Agenda
Village of Arlington Heights
Design Commission
Community Room, 3rd Floor

Arlington Heights Village Hall
33 S. Arlington Heights Road
Arlington Heights, IL 60005
May 26, 2015
6:30 PM

**MINUTES OF
THE VILLAGE OF ARLINGTON HEIGHTS
DESIGN COMMISSION MEETING
HELD AT THE ARLINGTON HEIGHTS MUNICIPAL BUILDING
33 S. ARLINGTON HEIGHTS RD.
MAY 12, 2015**

ALA
Job Number: 15068
Sheet Number: A202
File Name: 15068202

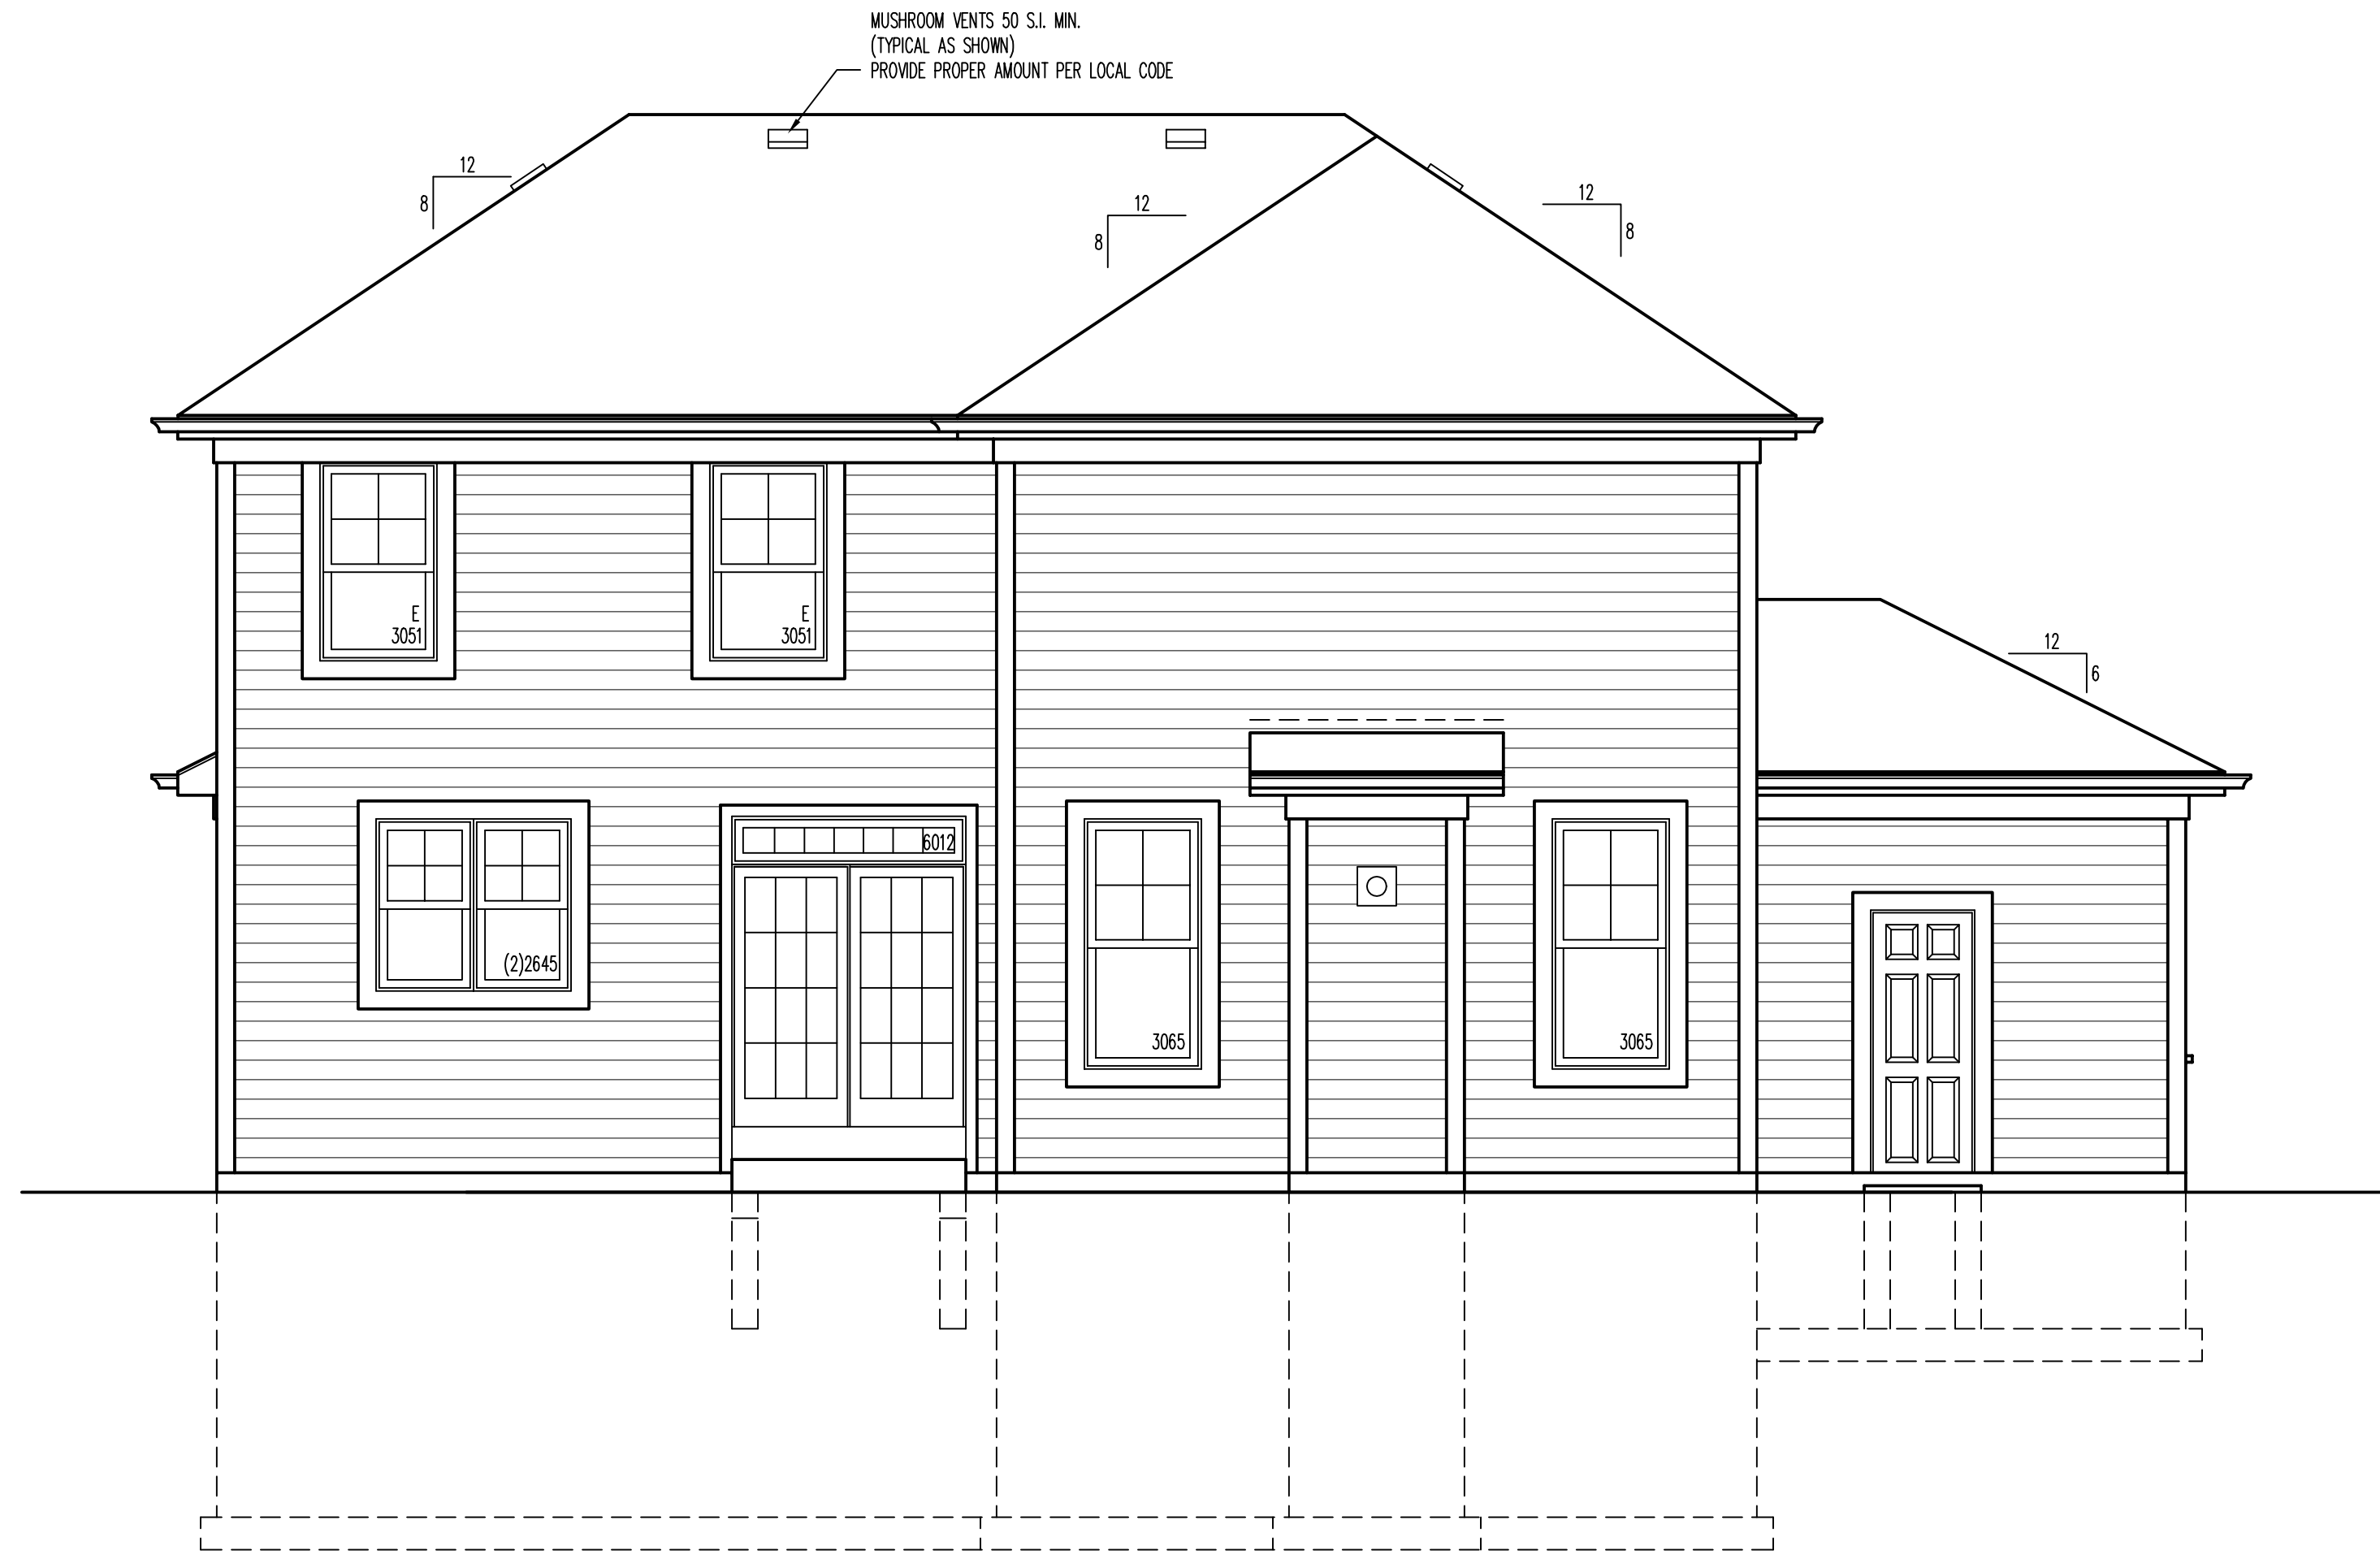
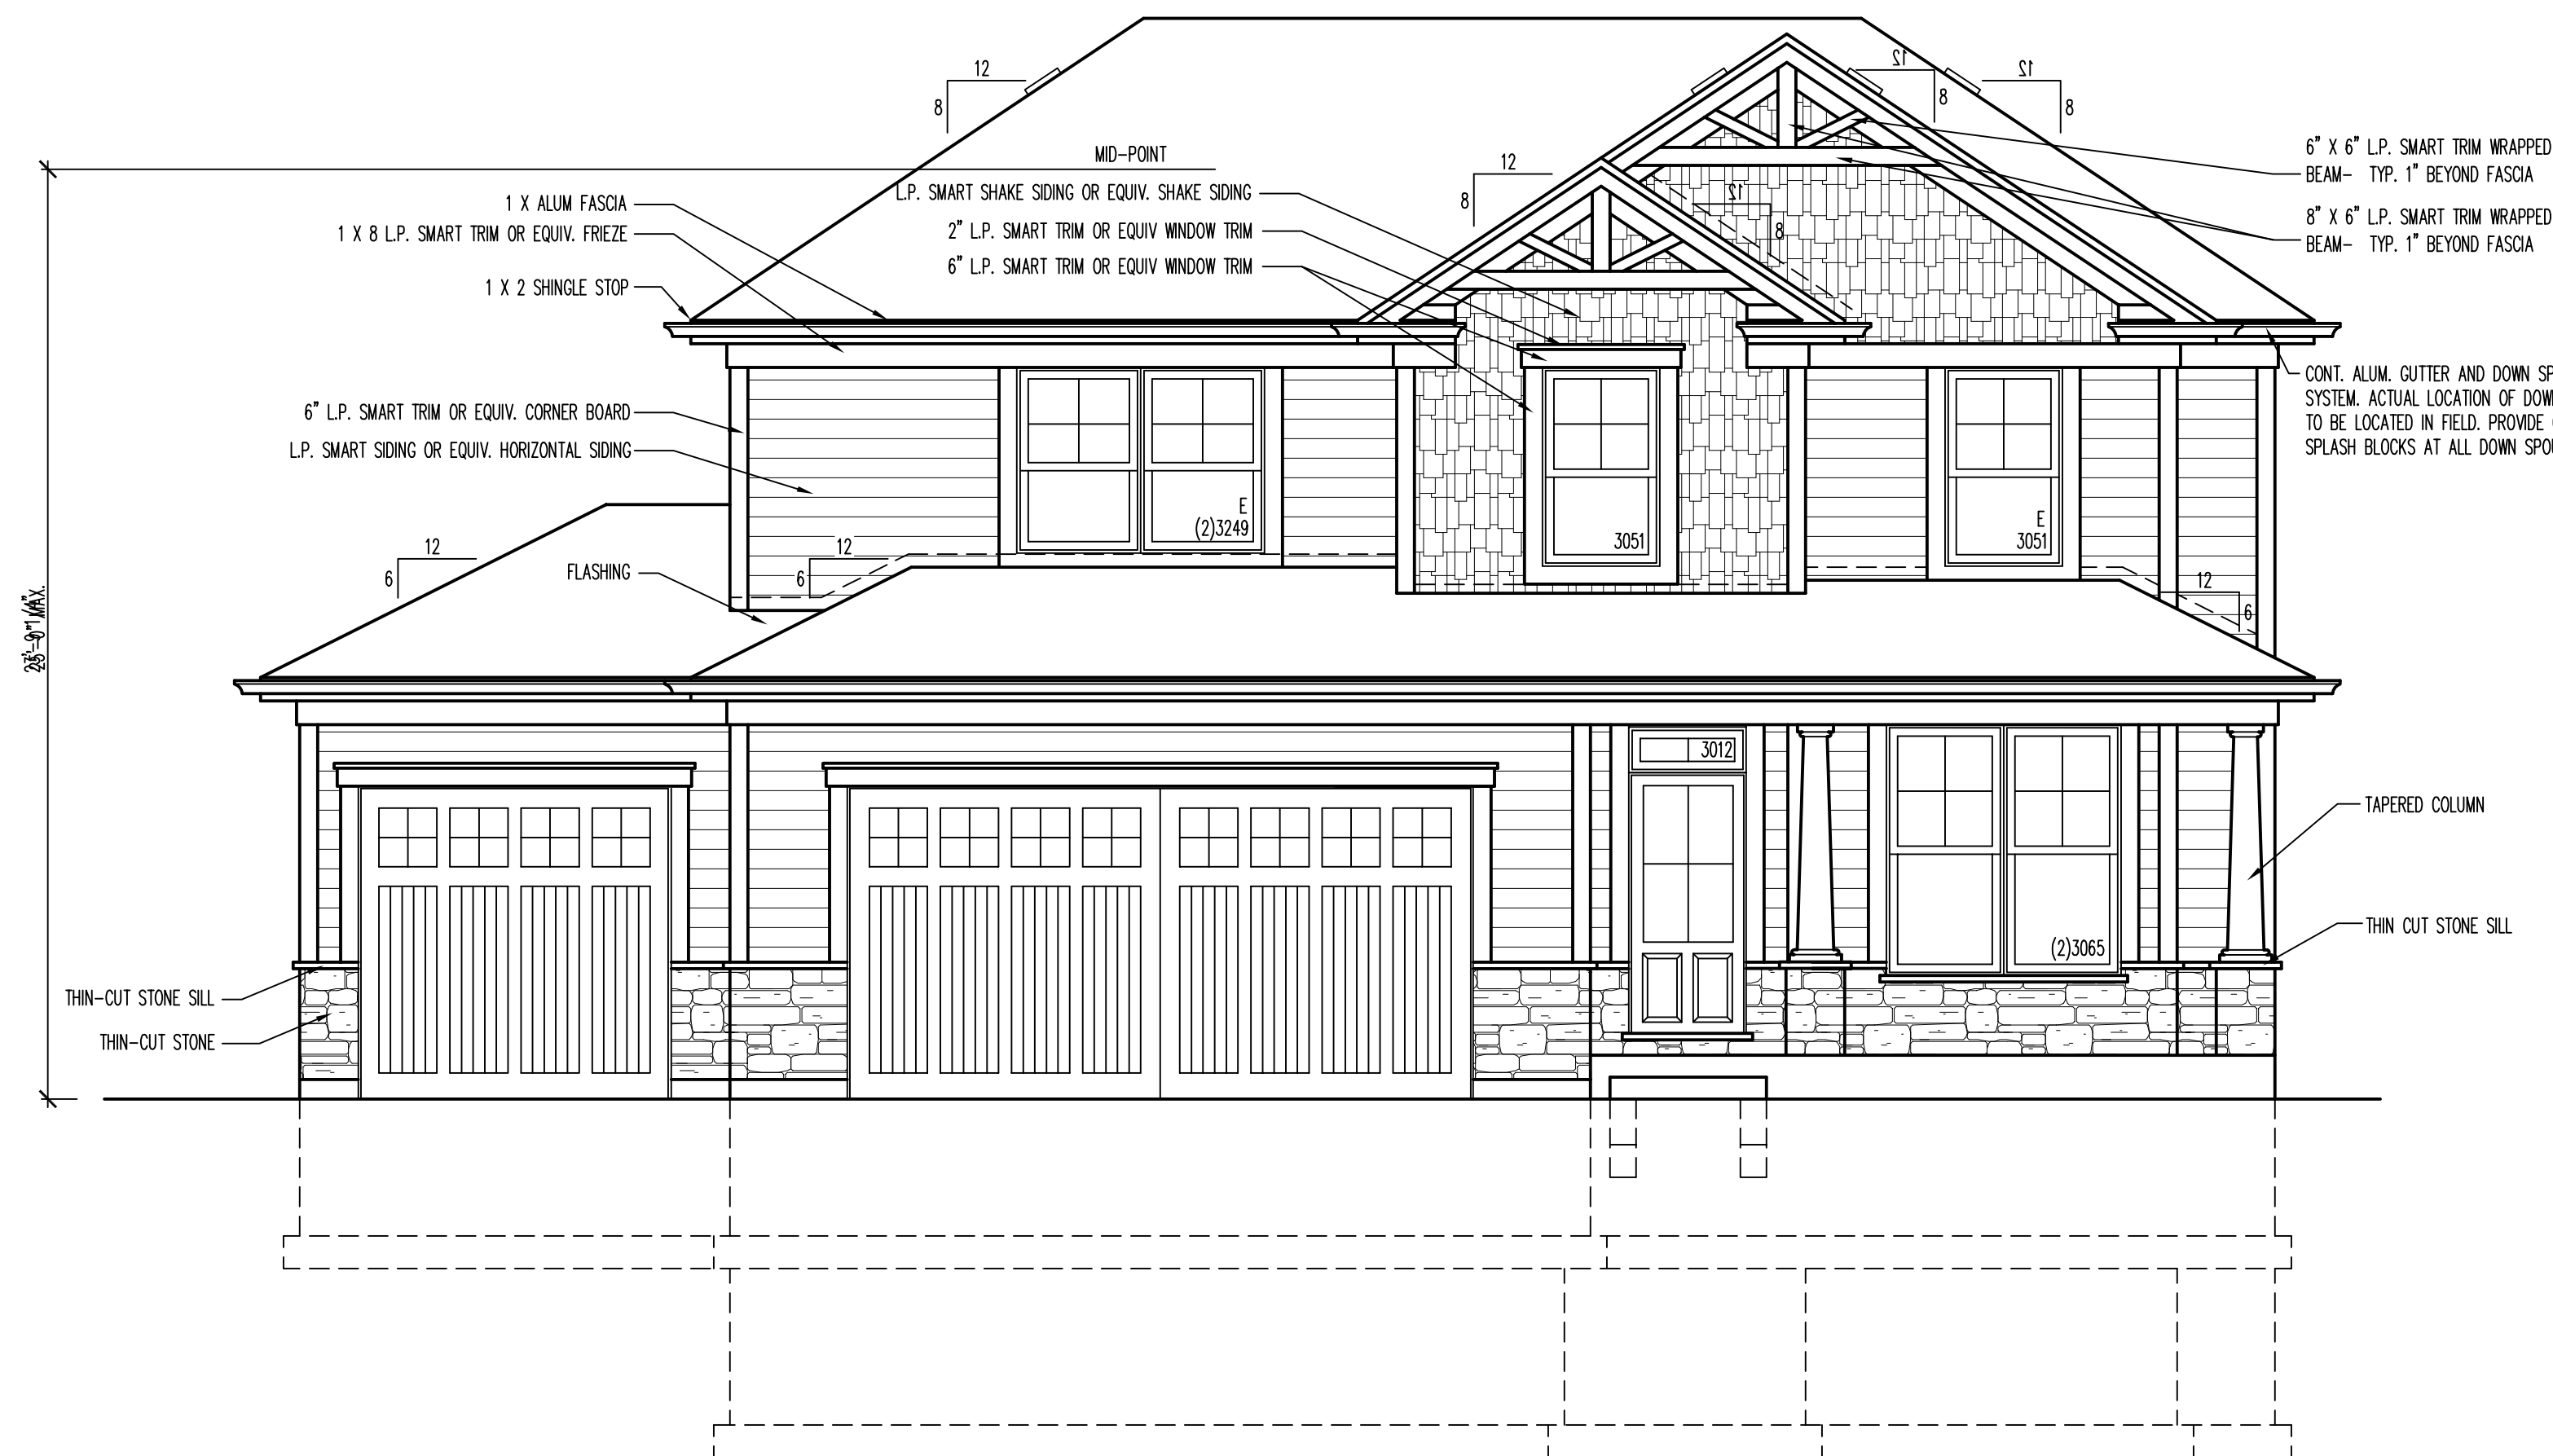
1. A recommendation to add a window and stone base to the side of the garage.
2. This review deals with architectural design only and should not be construed to be an approval of, or to have any other impact on, any other zoning and/or land use issues or decisions that stem from zoning, building, signage or any other reviews. In addition to the normal technical review, permit drawings will be reviewed for consistency with the Design Commission and any other Commission or Board approval conditions. It is the architect/homeowner/builder's responsibility to comply with the Design Commission approval and ensure that building permit plans comply with all zoning code, building permit and signage requirements.
3. Compliance with all applicable Federal, State, and Village codes, regulations and policies.

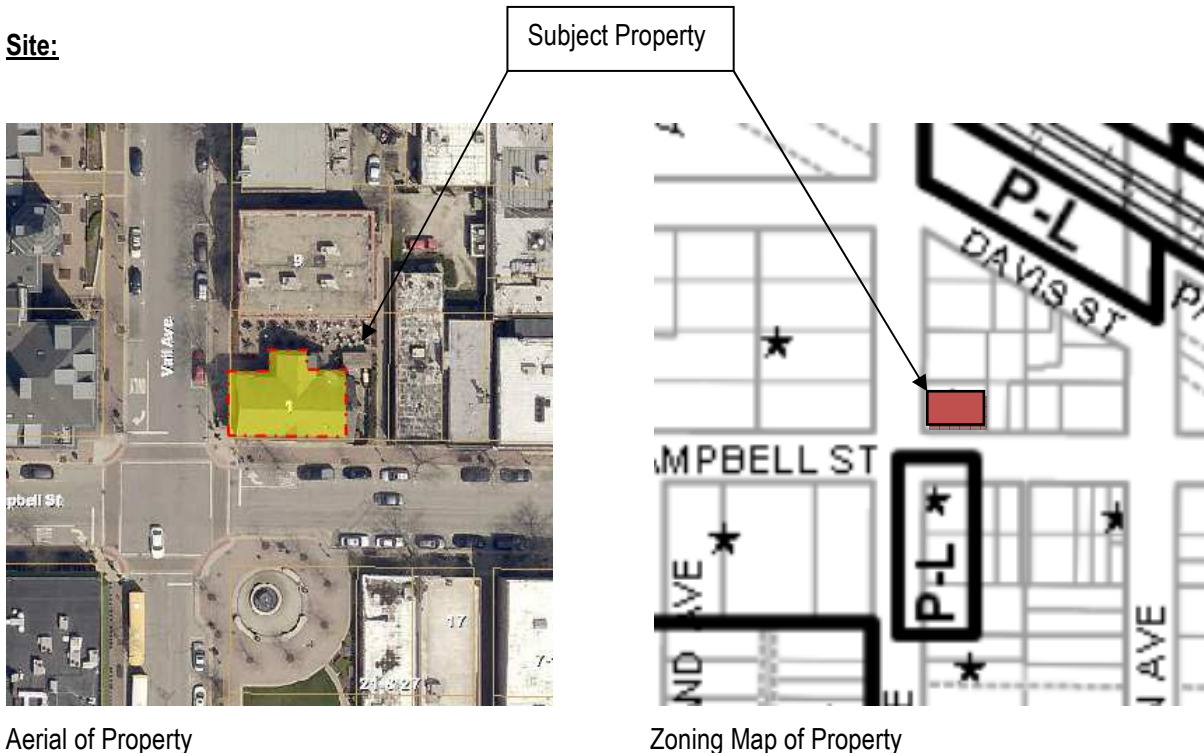
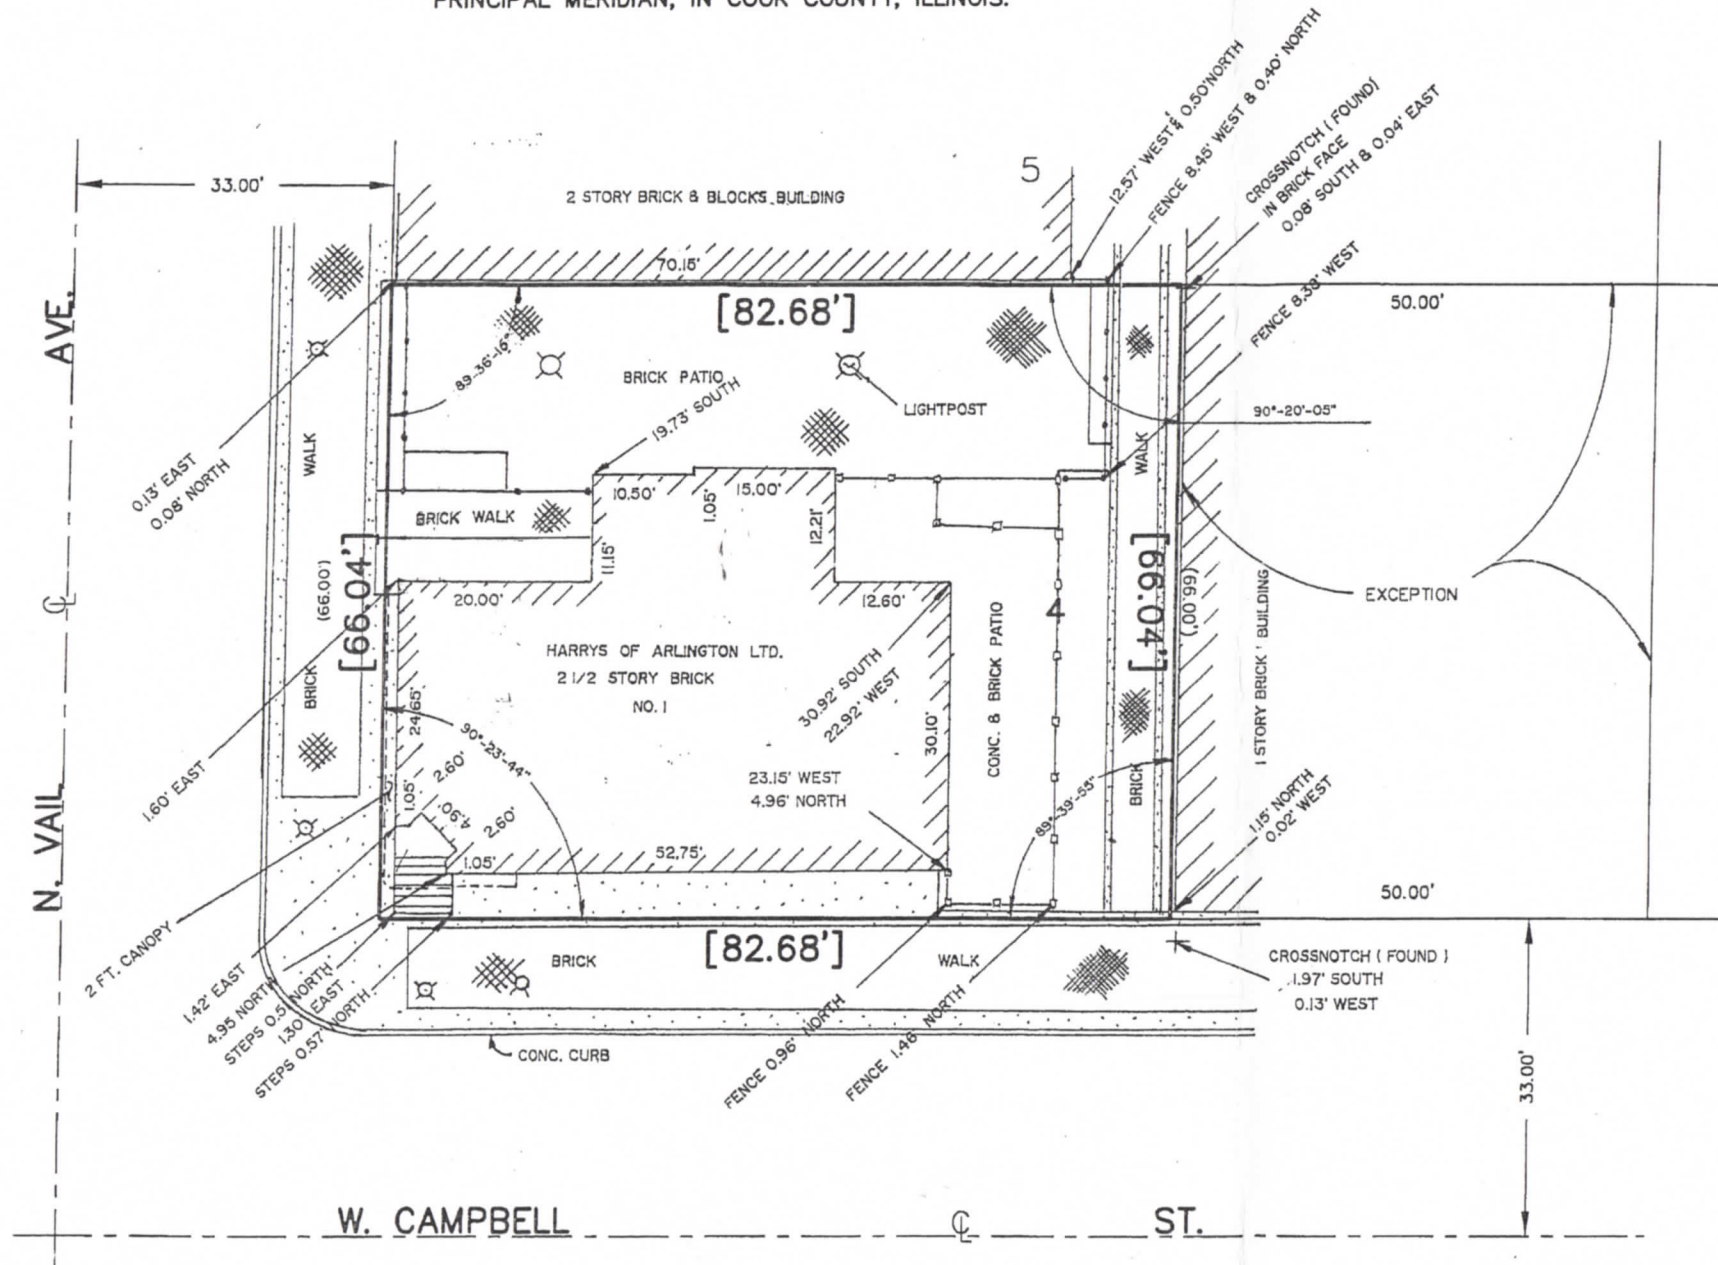
Although the proposed sign complies with code, it needs to be evaluated for compatibility with the architecture of the building and the context of the area. The proposed sign looks somewhat large on the corner of the building, although it does have a scale and proportion that complements the existing Circa '57 blade sign across the street. The approved architectural plans for the Cortland's Garage building (prepared by Tinaglia Architects) include a schematic design of a smaller scale corner projecting blade sign that works well with the architecture of the building, and should be considered by the Design Commission.
